NEW MEXICO
ENVIRONMENT DEPARTMENT

Hazardous Waste Bureau

February 17, 2012

RE: BOREHOLE GEOPHYSICAL LOGS, BULK FUELS FACILITY SPILL, SOLID WASTE MANAGEMENT UNITS ST-I06 AND SS-111, EMAIL OF DECEMBER 14, 2011 KIRTLAND AIR FORCE BASE, EPA ID# NM9570024423 HWB-KAFB-11-008

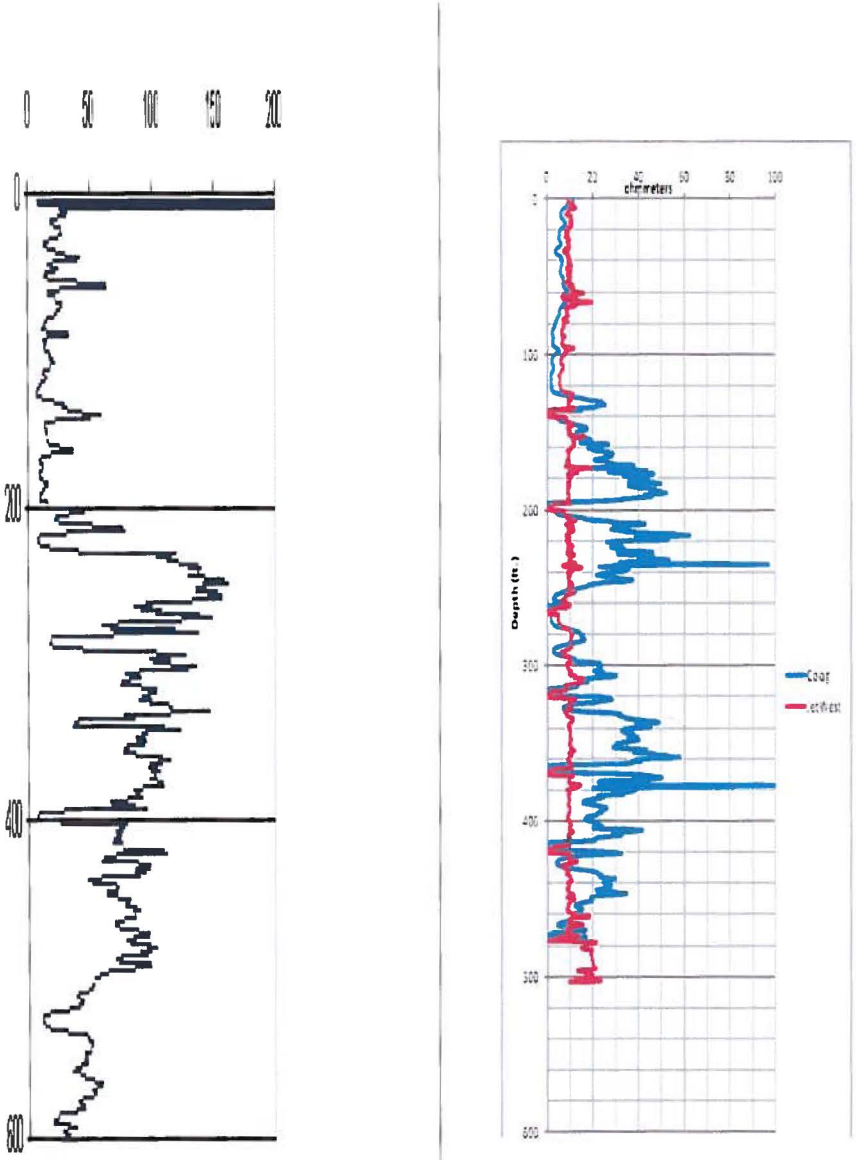
Typically, finer units, such as clays and silts, exhibit electrical resistivities that are lower than coarser units, such as sands and gravels (see Table 1 enclosed with this letter). Differences of about an order of magnitude or so would not be uncommon. At the Bulk Fuels Facility site there is an upper finer unit, Unit A, typically one hundred or more feet thick, and a deeper coarser unit, Unit B, that are shown on geologic cross-sections in the *Quarterly Pre-Remedy Monitoring and Site Investigation Report for April – June 2011*). It would be expected that these two units would have notably different average electrical resistivities based upon the lithologies described in the geologic logs. This is not the case with the Jet West induction logs. In contrast with the Jet West induction logs, the logs of other boreholes in the same area (and similar geology) show the expected variations. For example, Figure 1 shows electric logs from the upper portion of the Ridgecrest 5 production well, and the Jet West and Colog deep induction logs for KAFB-10624. The Jet West log does not show the expected variation in resistivity.

In conclusion, the Jet West induction logs are unreliable and are not useful. The Jet West induction logs fail to fulfill the work plan objective of collecting calibrated geophysical logs in all wells. Thus KAFB must repeat the geophysical logging of the wells. The newly-generated logs must be submitted to the NMED in both hard copy and electronic format by no later than May 17, 2012. The electronic version of the logs must be in a format useable by the NMED.

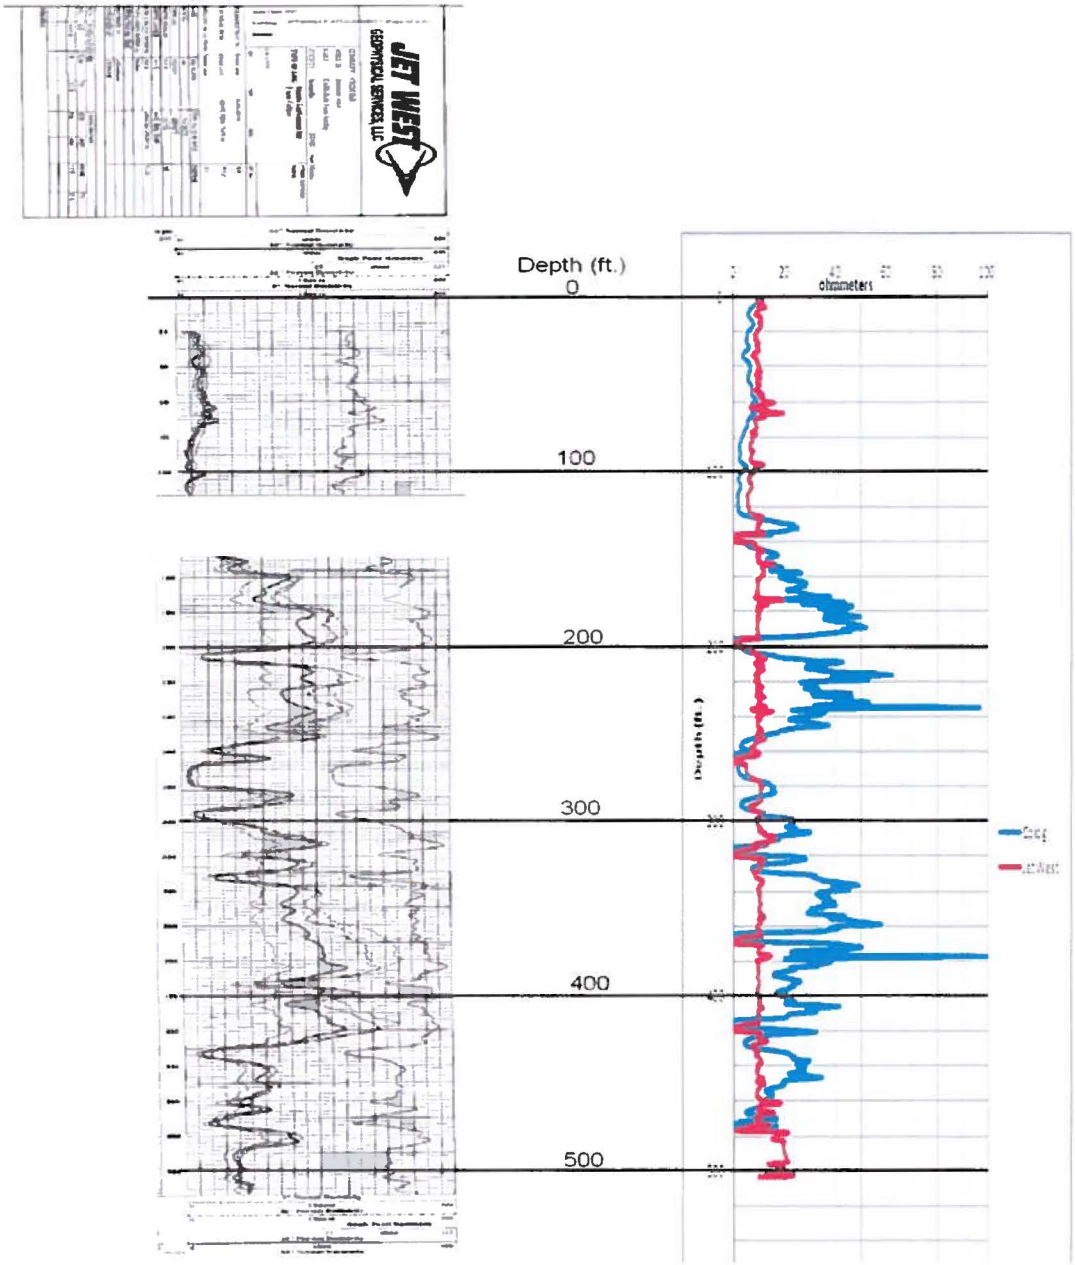
KAFB-10624 was logged by Jet West in 2009 as an open hole, and was logged as a cased hole by Colog in 2010 and again by Jet West in 2011. Figure 2 shows the 2009 Jet West log submitted in the November 2009 Semiannual Report as well as a composite Colog, 2010, and Jet West, 2011, deep induction logs. Again, note the variation of an order of magnitude or so for the logs except that for the 2011 Jet West log. An attenuation of resistivity due to casing and well construction material is expected, but it should not have been enough to cause the Jet West log to lose most of its definition, an argument further supported by the Colog log which did not have such a problem.
